Access Compliance Report Public Rights-of-Way (Curb Ramps)

Main Street: CASTLEGATE_LN Cross Street: ARROYO_AVE Location: N

ADA ID: RPRK211011105620 Ramp Type: Type 1 - Perpendicular Diagonal Initial Pass/Fail: Fail Overall Compliance: No Severity Score: 32

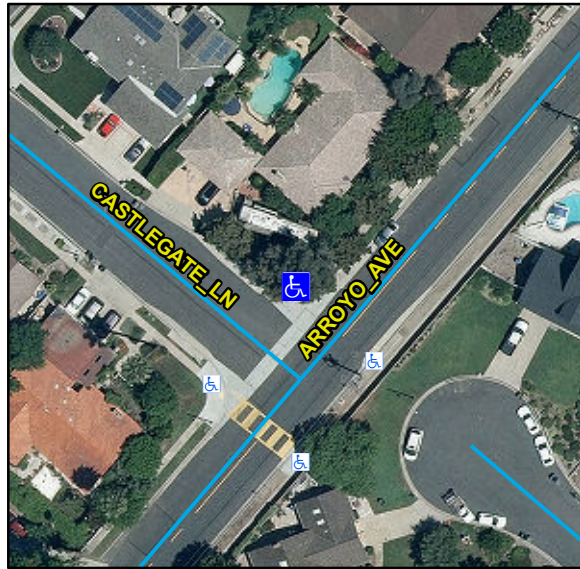
Compliance	Description	Data	Compliance	Description	Data
N/A	Ramp Length (in)	104	N/A	Flare Type LT	
Yes	Ramp Width (in)	48			N/A
No	Ramp Run Slope (%)	13.8	N/A	Flare Slope LT (%)	N/A
No	Ramp Cross Slope (%)	2.1	N/A	Flare Traversable LT	N/A
N/A	Landing Present	N/A	N/A	Flare Type RT	
N/A	Landing Length (in)	N/A			N/A
N/A	Landing Width (in)	N/A	N/A	Flare Slope RT (%)	N/A
N/A	Landing Run Slope (%)	N/A	N/A	Flare Traversable RT	N/A
N/A	Landing Cross Slope (%)	N/A	N/A	DWS Provided	N/A
N/A	Landing Movement Obstructed?	N/A	N/A	DWS Contrast	N/A
	Landing Movement Type	N/A	N/A	DWS Length (in)	N/A
N/A	Landing Shared	N/A	N/A	DWS Full Width	N/A
N/A	Clear Space	Yes	N/A	DWS Offset Left (in)	N/A
N/A	Clear Space To Crosswalk (in)	N/A	N/A	DWS Offset Right (in)	N/A
N/A	Marked Crosswalk 1	No	N/A	Marked Crosswalk 2	No
	Crossing 1 Direction	SW		Crossing 2 Direction	SE
	Marked Crosswalk 1 Width (in)	N/A		Marked Crosswalk 2 Width (in)	N/A

N/A	Ramp Inside Crosswalk 1	N/A	Yes	Ramp Inside Crosswalk 2	N/A
	Crossing 1 Slope (%)	8.1		Crossing 2 Slope (%)	7.1
	Crossing 1 Cross Slope (%)	3.6		Crossing 2 Cross Slope (%)	1.7
N/A	Gutter Ponding	N/A	No	Curb Slope	13.9
Yes	Gutter Lip Height (in)	0		Road Run Slope (%)	2
N/A	Gutter Run Slope (%)	N/A		Road Cross Slope (%)	6.6
N/A	Gutter Cross Slope (%)	N/A			
Yes	Overall Surface Condition: Acceptable		Yes	Perp Joint Present	Yes
	Cross Gutter Present?	Yes		Spandrel Present?	Yes
	Replace Cross Gutter?	No		Replace Spandrel?	No

Remove & Replace Curb Ramp With Two New Directional Ramps or Equivalent.

R304.2.2, R304.5.3, STD 1115
